EXTERNAL INTERFERENCE ON TOUCH DISHWASHERS

ASSEMBLY SEQUENCE :

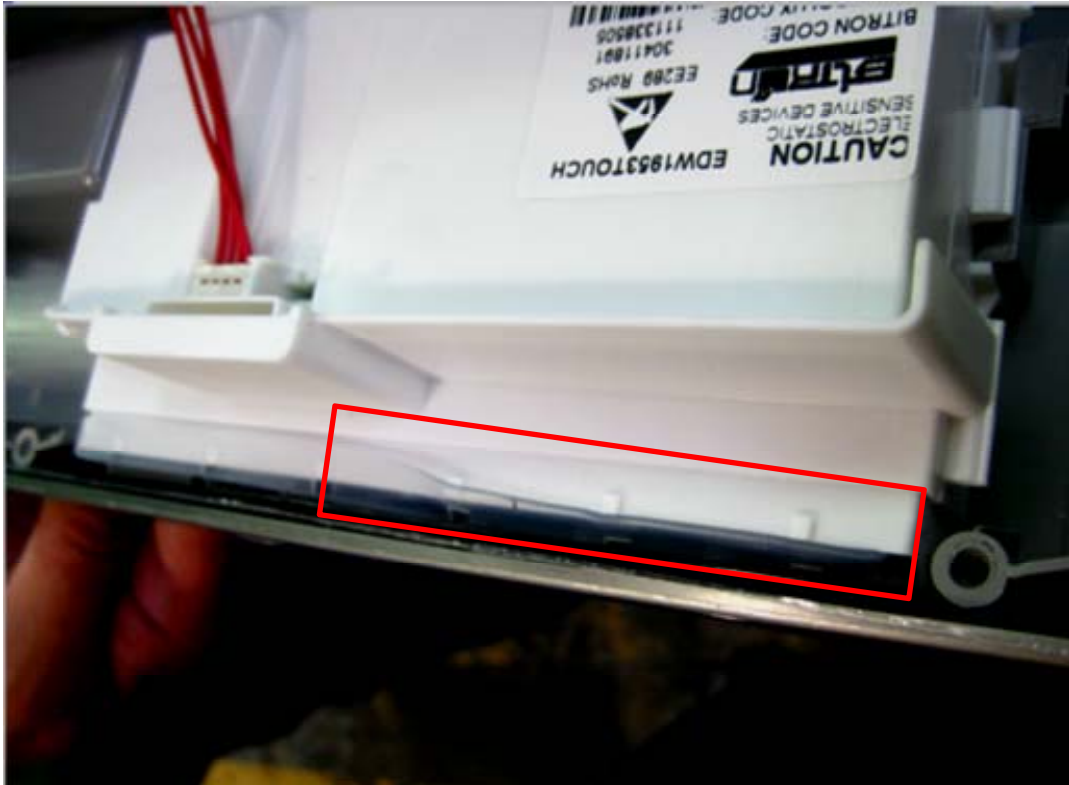
On the markets in some occasion has been detected a bad functioning of the dishwashers during the selection of the programs/options due to external interference coming from the power supply or other electronics device.

Consider also that a bad functioning of the dishwashers during the selection of the programs/options can due to an incorrect assembling of the transparent plastic cover (see picture below)

Since week 48/2011 has been implemented a "Filter", on the touch appliances interested In the appliances highlighted in the list below and produced until the week 47/2011 (serial number 147xxxxxx), in presence of problems due to external interference, is necessary to use the filter.

Spare Part Code Filter: 1174144012
